ASSESSMENT REPORT

Section 75W Modification Advanced Waste Treatment Facility (06_0185 MOD 3)

Figure 4 – Proposed modification

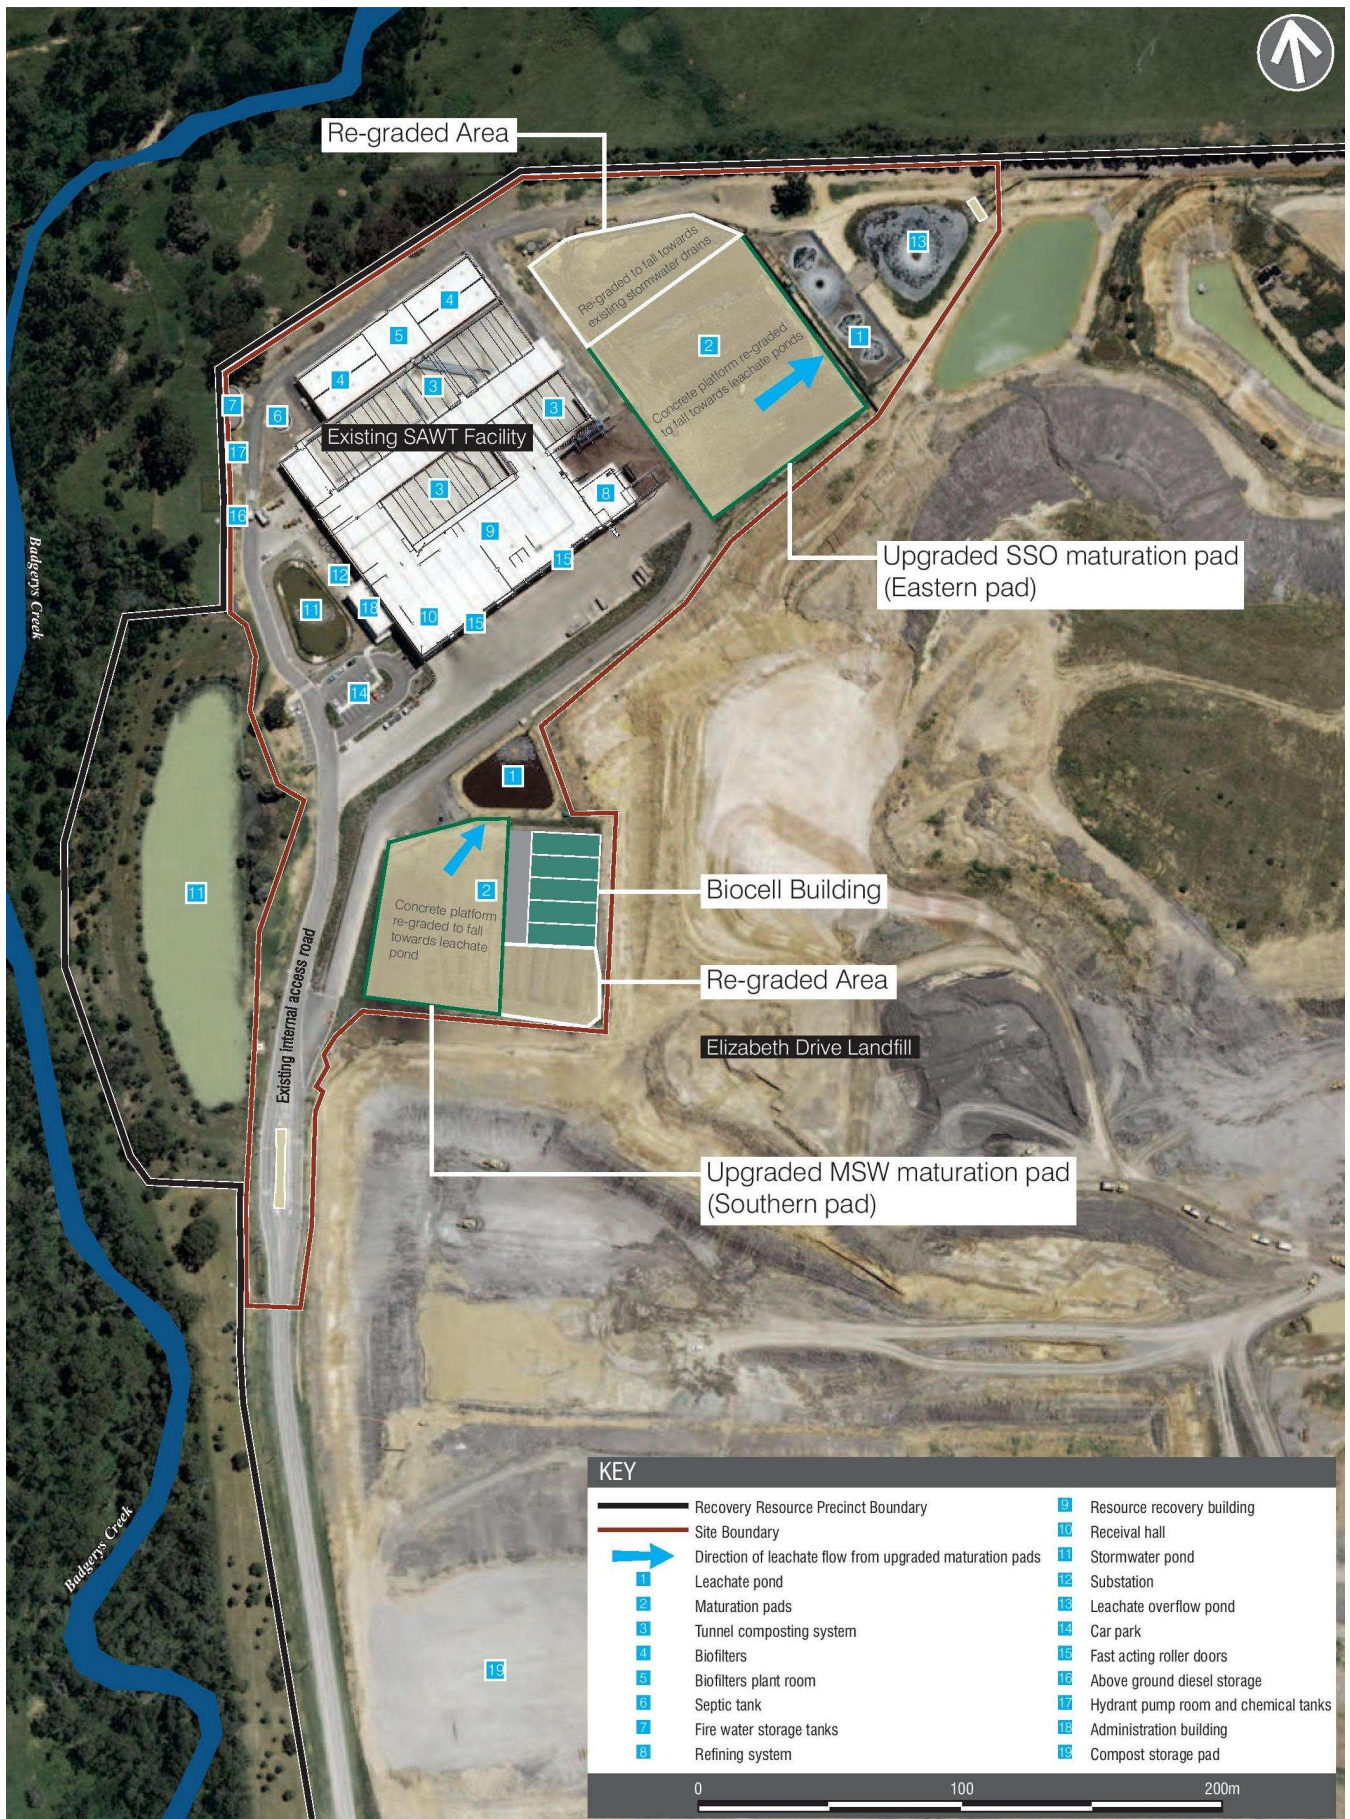
- upgrading the compost maturation pads from compacted earth to concrete to improve drainage and to prevent leachate from pooling;
- using impermeable plastic covers over the compost windrows during rainfall to reduce leachate production and prevent the compost from saturating; and
- constructing a bio-cell, which uses mechanical ventilation to accelerate the compost maturation process (see **Figure 4**).

The bio-cell would be a covered and partially enclosed concrete structure; 50 m long, 30 m wide and 7 m high, with 5 separate compartments. Partially matured compost would be transferred from a windrow to a bio-cell compartment (in batches) where mechanical ventilation would accelerate the final stages of compost maturation by sustaining aerobic conditions and precise moisture control. The bio-cell would have capacity to refine about 2,000 tonnes of compost every 2 weeks.

Issue	Consideration	Recommendation
Odour	<ul style="list-style-type: none"> • The proposed modification is intended to address key areas of odour generation within the existing compost maturation process at the AWTF. • Odour from this process is likely the cause of odour complaints about the facility from nearby landowners, and was considered likely to be responsible for detectable off-site odours in the EPA's <i>Western Sydney Regional Odour Assessment 2013</i>. • Key areas of odour reduction in the modification include: <ul style="list-style-type: none"> ○ concrete maturation pads, which would eliminate standing leachate from depressions in the existing earthen maturation pads; ○ plastic covering for the compost windrows (during rainfall), which would reduce leachate generation, and improve moisture control in the compost material; and ○ a bio-cell, which uses mechanical ventilation to maximise aerobic conditions in the compost material, thereby accelerating the final stage of maturation and also producing less odorous compost. • A significant benefit of the modification would be improved operational reliability during bad weather, preventing the accumulation of wet compost in stockpiles (and attendant odours) resulting from rainfall. • The Department is satisfied that the proposed modifications are relatively minor and could be implemented quickly. They have the potential to noticeably reduce odour emissions from the AWTF. • Odour management at the AWTF is already governed by a suite of existing approval conditions. The Odour Management Plan should be updated to reflect the new composting processes. • Any ongoing odour concern with the site would be captured by the annual reviews or tri-ennial independent audits, which are required by the existing conditions. • The Department does not consider that further approval conditions are necessary. 	<p>Require applicant to:</p> <ul style="list-style-type: none"> • update the existing Odour Management Plan to reflect the new composting processes and structures.

Noise	<ul style="list-style-type: none"> • The proposed biocell includes mechanical ventilation fans, which would operate 24 hours per day. • SITA has committed to install fans (and fan silencers) that minimise the generation of noise from the biocell and comply with its existing noise related approval conditions. • SITA has also committed to measure the noise performance of the fans (once installed) and install any additional reasonable and feasible noise controls that may be necessary. • The existing noise conditions were established under the EPA's current Industrial Noise Policy and the Department 	<p>Require applicant to:</p> <ul style="list-style-type: none"> • update the existing Noise Management Plan to reflect the additional infrastructure and commitments. • update the existing Construction Noise Management Protocol.
